US 27/SR 1 - HAMILTON ROAD WIDENING
Project No. NH-017-1(20)
P.I. No. 322250
Troup County

Value Engineering Study Report
Preliminary Design Submittal

December 2007

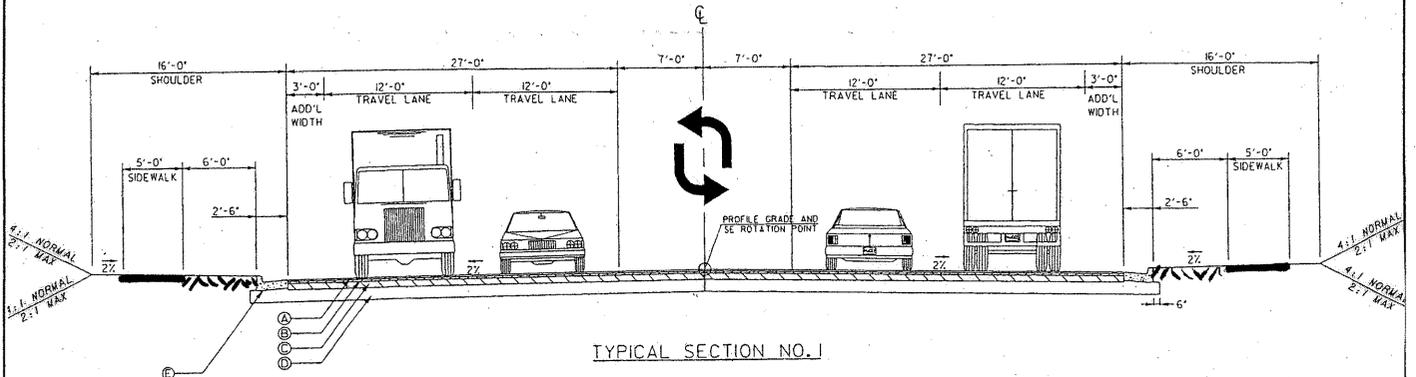
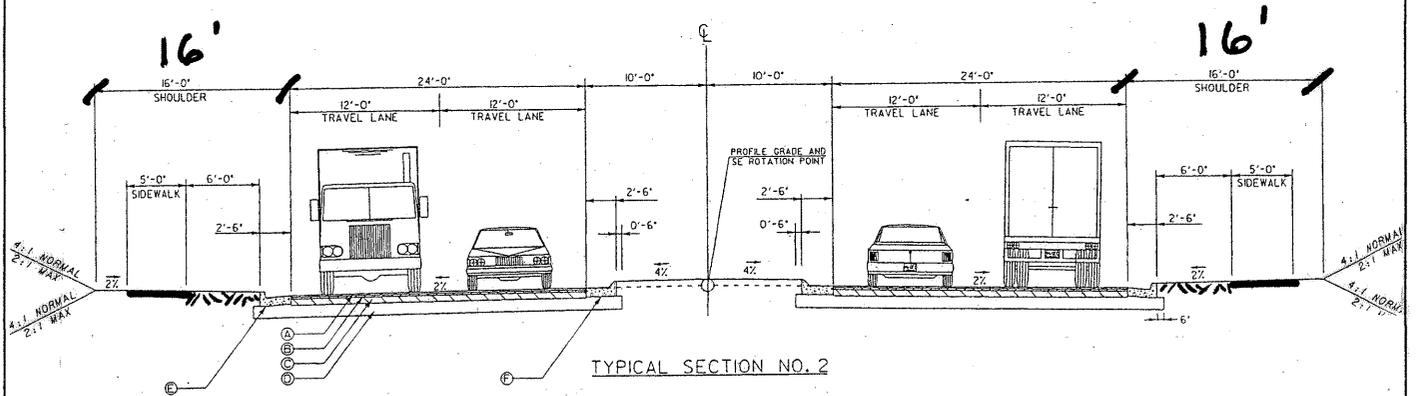
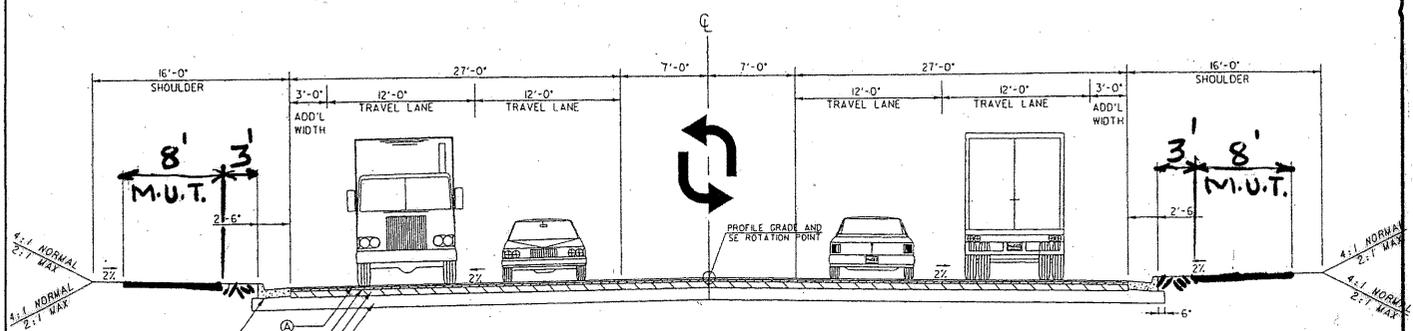
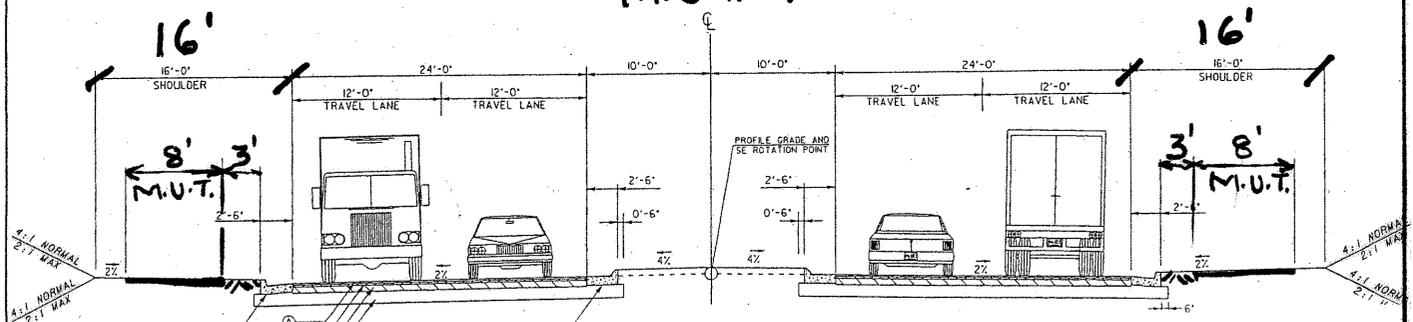
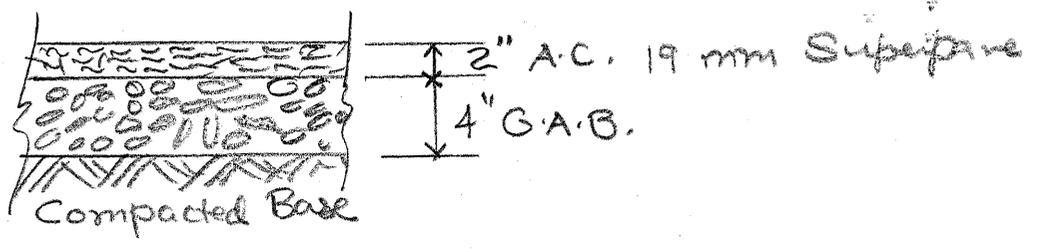
Reduce the width of the grassed shoulder from 6 ft. to 3 ft. on both sides of Hamilton Road. Instead of providing a 5-ft.-wide concrete sidewalk, provide an 8-ft.-wide multi-use asphalt trail.

Constructing an 8-ft.-wide asphalt multi-use trail saves money and provides an avenue for bicyclists. A 3-ft.-wide grassed shoulder between the multi-use trail and curb is plenty of space for pedestrian safety.

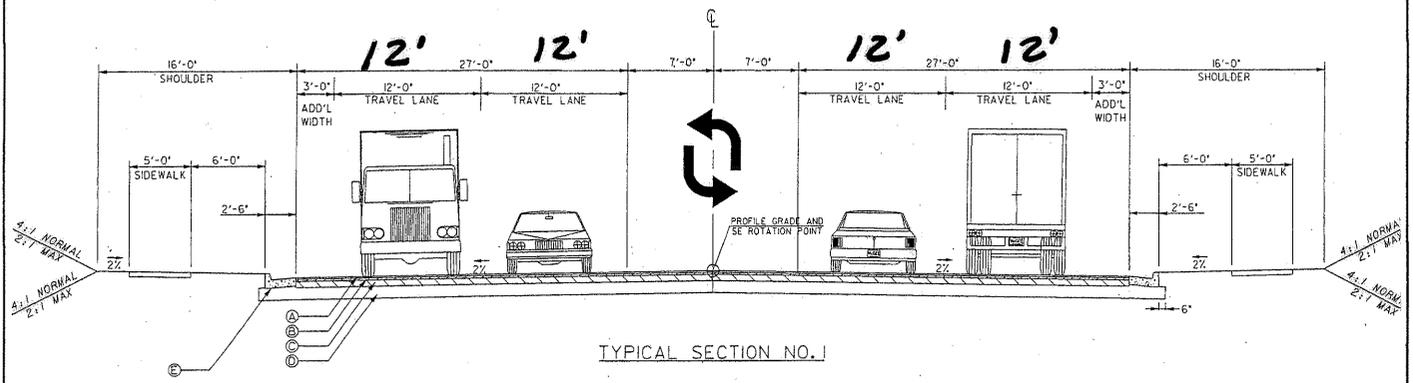
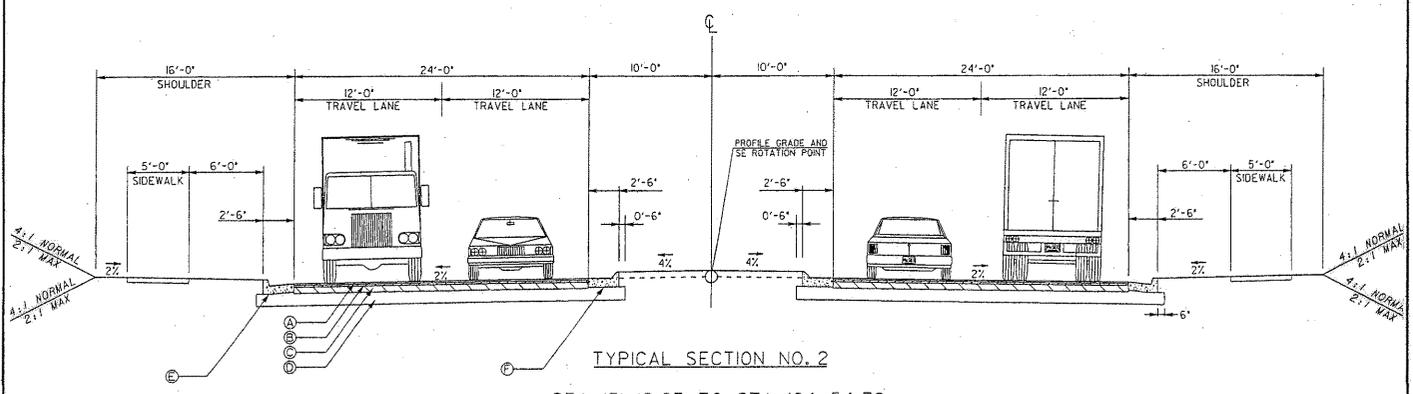
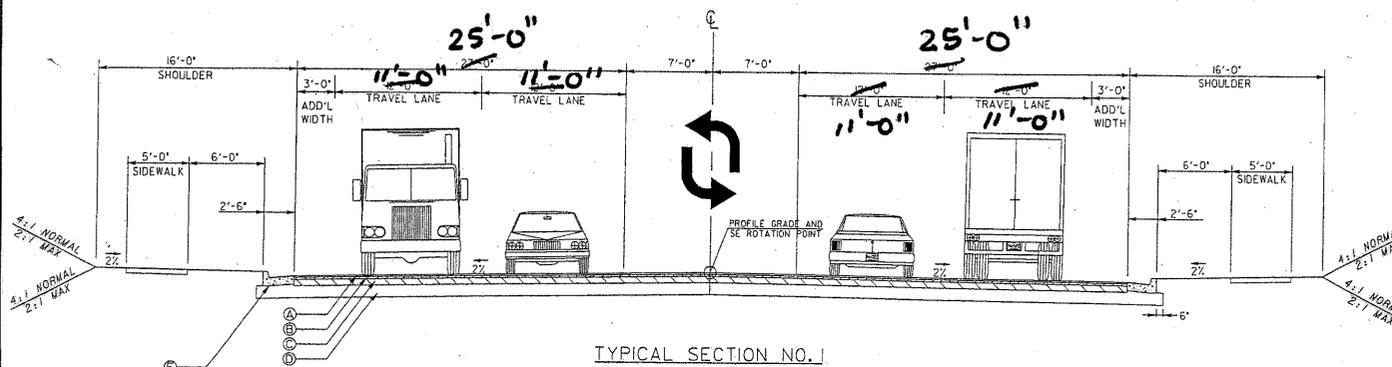
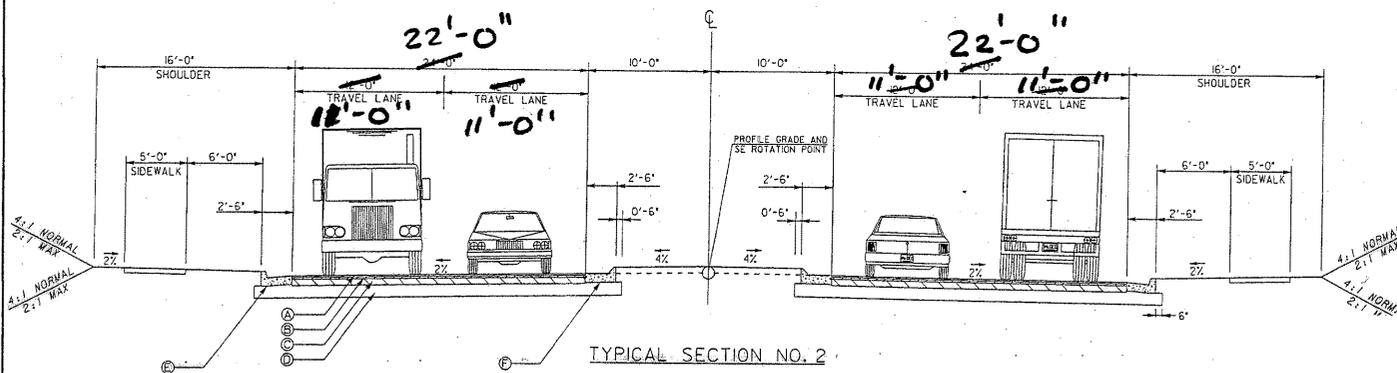
Provide two 11-ft. through lanes in both directions on Hamilton Road.

Eleven-foot lanes exist on freeways in metropolitan Atlanta. This has not caused any safety issues. For Hamilton Road, the inside lane is either next to 14 ft. or 20-ft. wide medians. The outside lane is either next to 3 ft. of additional pavement or a 30-in. curb and gutter. In all cases, existing width provides additional safety.

S-10

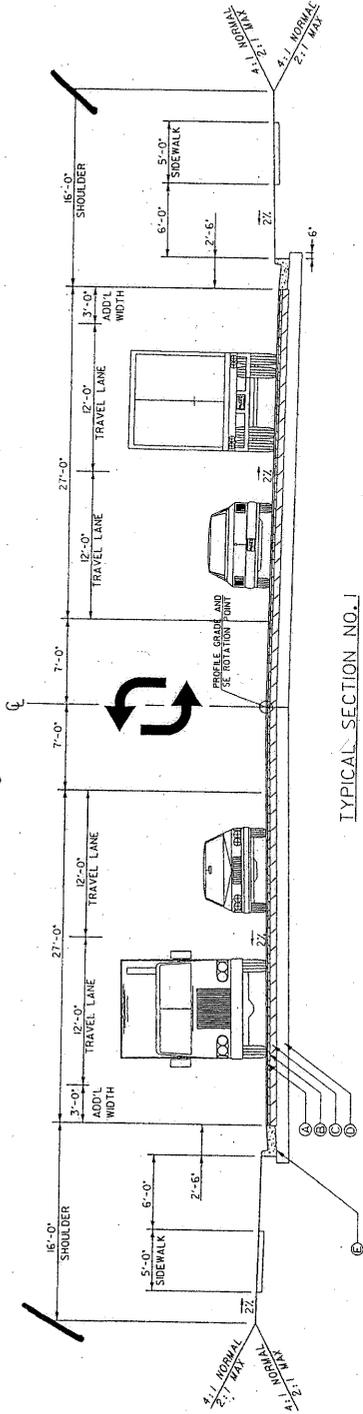
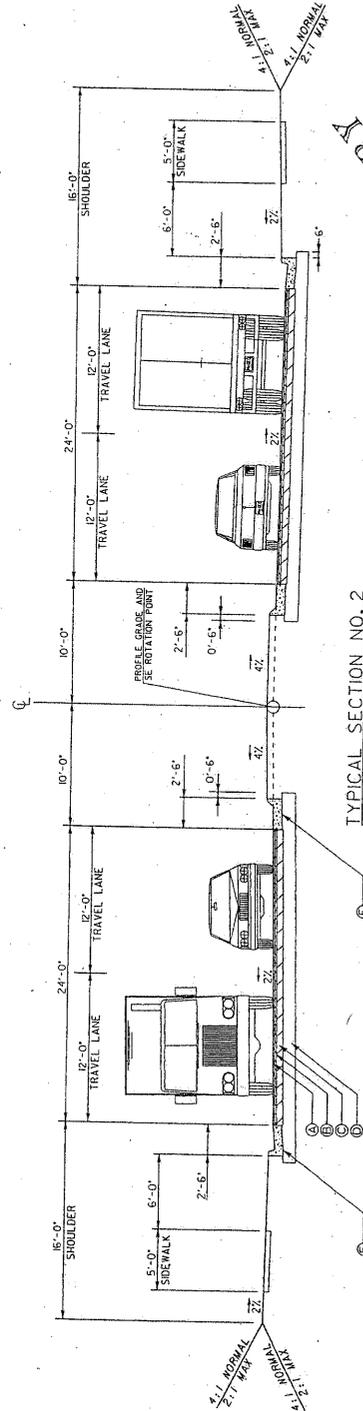
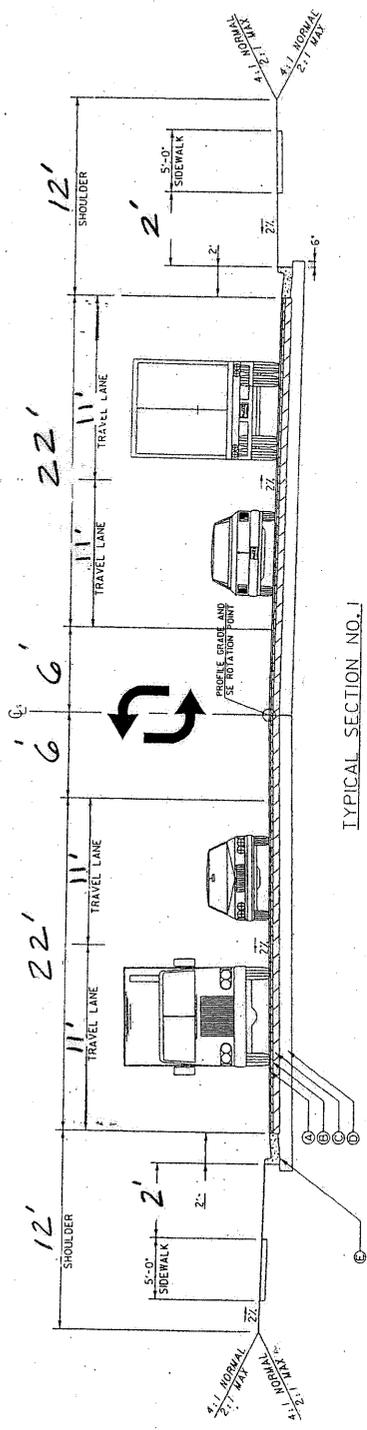
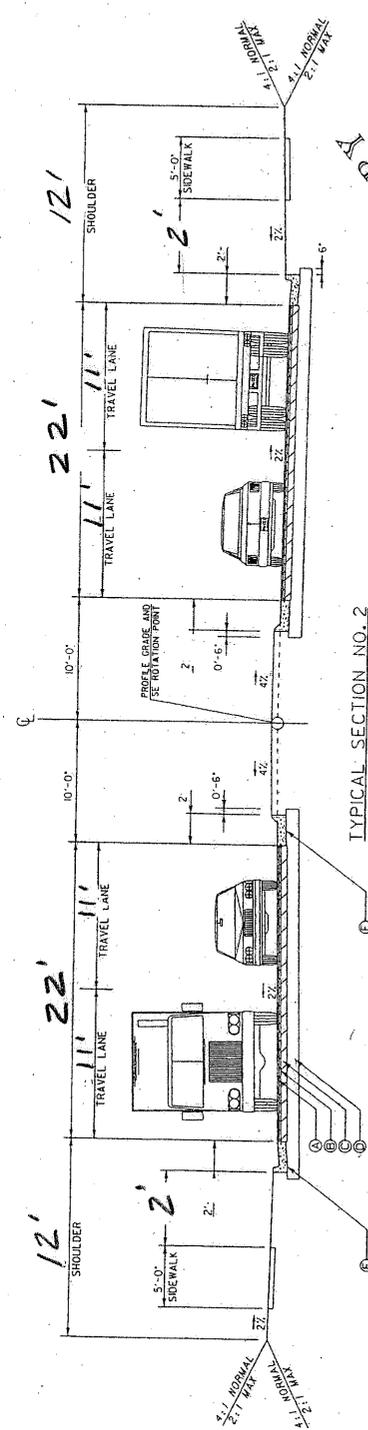
VE Alternate #1 Typical Section

S-11

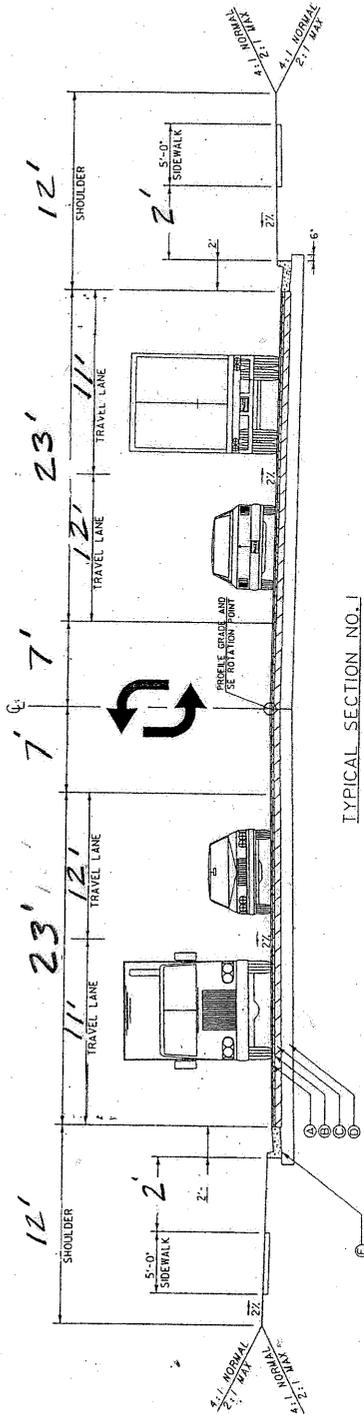
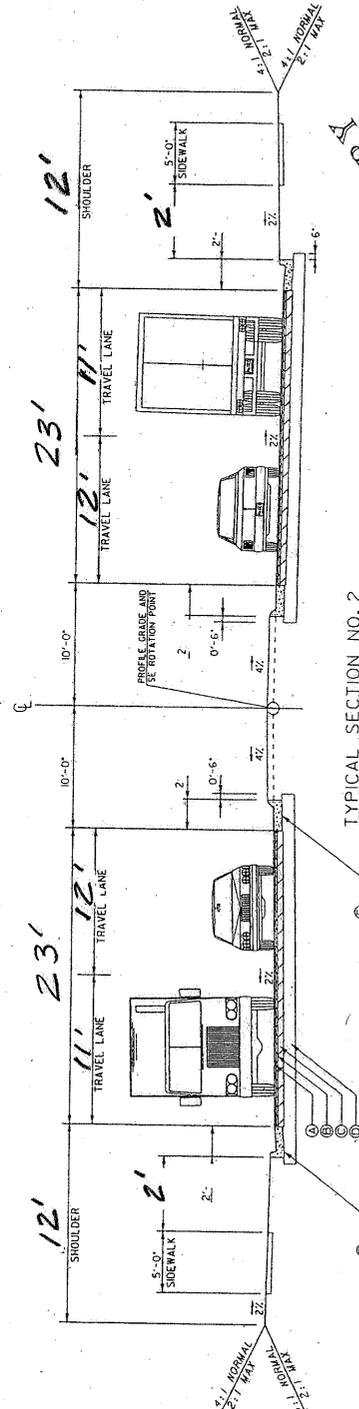
VE Alternate "2" Typical Section
